# UNITED STATES PATENT AND TRADEMARK OFFICE

APPLICATION NO.	FILING DATE	FIRST NAMED INVENTOR	ATTORNEY DOCKET NO.	CONFIRMATION NO.
09/957,451	09/21/2001	Marc O. Schurr	06530.0276-00000	2507

# Office Action Summary

**DETAILED ACTION**

**FIG. 10**

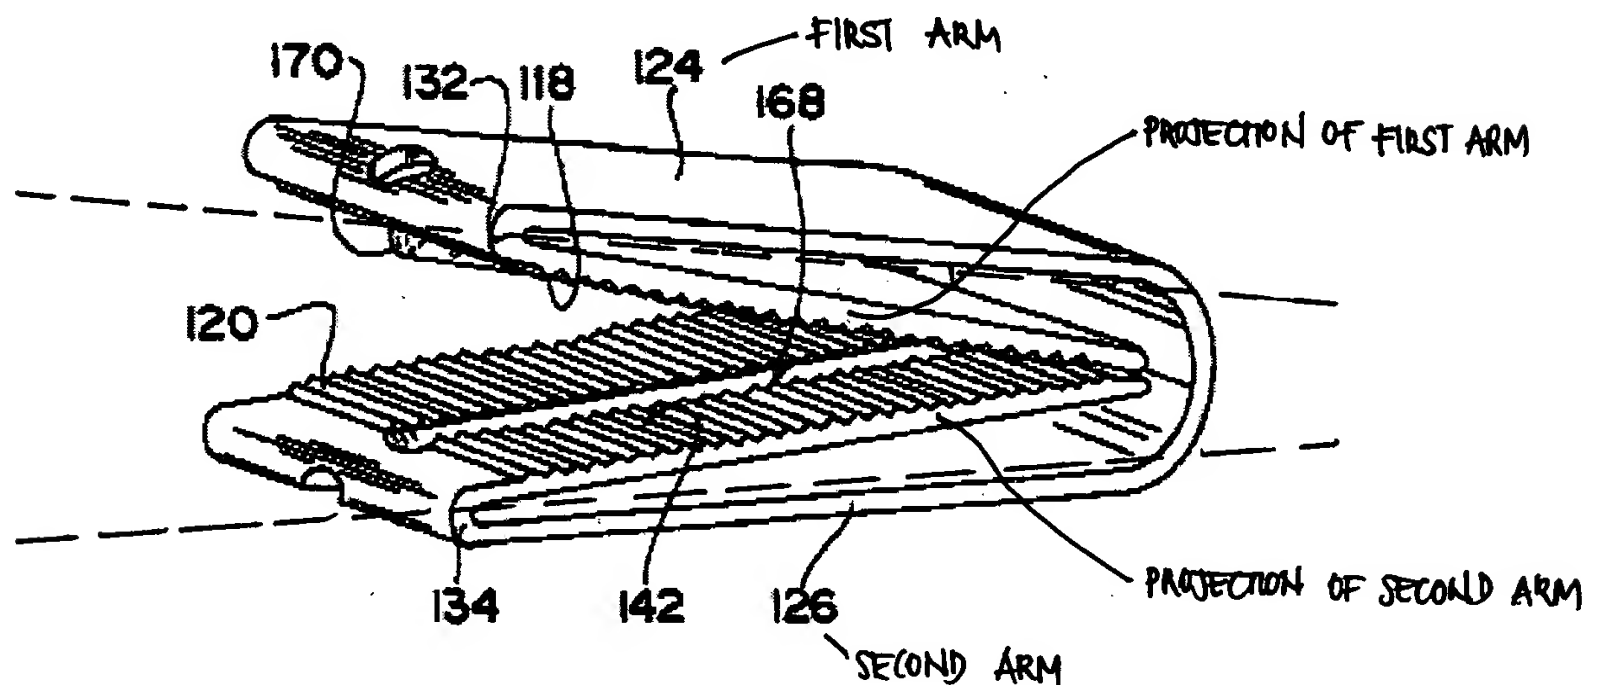
(claims 1, 120, 135 and 148) Figs. 9 and 10 of Yoon discloses a clip that is fully capable of securing a fold of tissue for treating GERD, the clip comprising:

a first arm **124**;

a second arm **126** disposed substantially opposite from each other,

wherein the first and second arms have a first end fixedly connected to each other to define an opening that is capable of receiving a fold of tissue (the clip shown in Fig. 10 is in an open position and can receive tissue),

wherein the first and second arms extend substantially in the same direction as the fold of tissue (see Figs. 9 and 10),

wherein the opening allows tissue to extend beyond a second end of the first and second arm (the clip merely compresses on any object/tissue located between the first and second arms and does not limit any tissue from extending beyond the ends 132 and 134),

wherein the second end of the first and second arms are capable of maintaining a non-contacting relationship when in a deployed stated (when an object/tissue is located between the first and second arms),

wherein the first and second arm includes integral anchoring portions (see attached figure below) which are projections that are capable of maintaining a non-contacting relationship with the other of the first and second arms during a deployed state,

(claims 7, 134, 147 and 157) The first arm and second arm forms a substantially U-shaped configuration, see attached figure above.

(claim 121) The anchoring portion, as illustrated above, is fully capable of engaging a fold of tissue therebetween.

(claims 124, 126, 127, 137, 138, 140 and 149-152) The anchoring portion comprises of two projections, one from each arm and located opposite to one another, and are in the form of a reverse angle barb (see attached figure above).
